Access Compliance Report

Public Rights-of-Way

(Curb Ramps)

Intersection ID: N/A	Main Street: INDEPENDENCE_RD	Cross Street: N/A	Location: E
ADA ID: 47EC1934F68C	Ramp Type: PerpDiag	Initial Pass/Fail: Fail	Overall Compliance: No
			Severity Score: 21.25

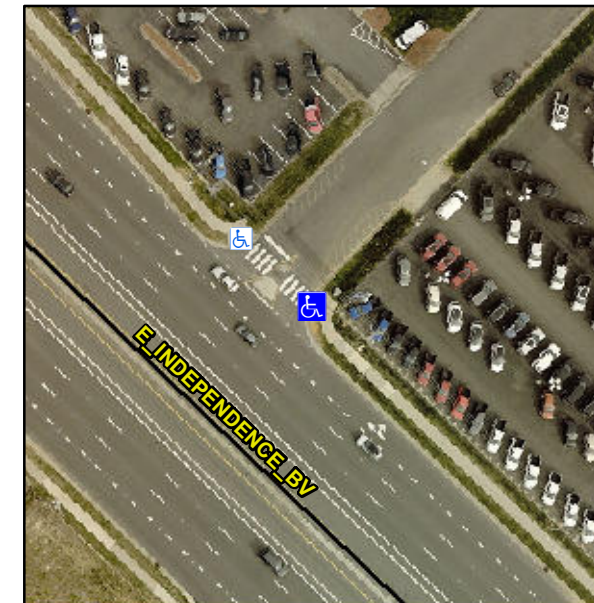
Not Found, R304.5.1, R304.5.3

Compliance	Description	Data	Compliance	Description	Data
N/A	Ramp Length (in)	72.0	Yes	Ramp Slope (%)	8.1
No	Ramp Width (in)	47.5	No	Ramp XSlope (%)	6.9
N/A	Flare Type LT	N/A	N/A	Flare Type RT	N/A
N/A	Flare Slope LT (%)	N/A	N/A	Flare Slope RT (%)	N/A
N/A	Flare Traversable LT?	N/A	N/A	Flare Traversable RT?	N/A
N/A	Landing Length (in)	N/A	N/A	DWS Provided?	N/A
N/A	Landing Width (in)	N/A	N/A	DWS Contrast?	N/A
N/A	Landing Slope (%)	N/A	N/A	DWS Length (in)	N/A
N/A	Landing X Slope (%)	N/A	N/A	DWS Full Width?	N/A
N/A	Landing Curb? (Y/N)	N/A	N/A	DWS Offset (in)	N/A
N/A	Shared Landing?	N/A			
N/A	Gutter Ponding?	N/A	N/A	Gutter Slope (%)	N/A
N/A	Gutter Lip Ht (in)	N/A	N/A	Gutter X Slope (%)	N/A
N/A	Painted X Walk1?	Yes	N/A	Painted X Walk2?	No
	X Walk 1 Direction	To NW		X Walk 2 Direction	To SW
N/A	X Walk 1 Width (in)	119.0	N/A	X Walk 2 Width (in)	N/A
	X Walk 1 Slope (%)	7.8		X Walk 2 Slope (%)	5.1
	X Walk 1 X Slope (%)	4.1		X Walk 2 X Slope (%)	1.3

Remove & Replace Curb Ramp With Two New Directional Ramps or Equivalent.
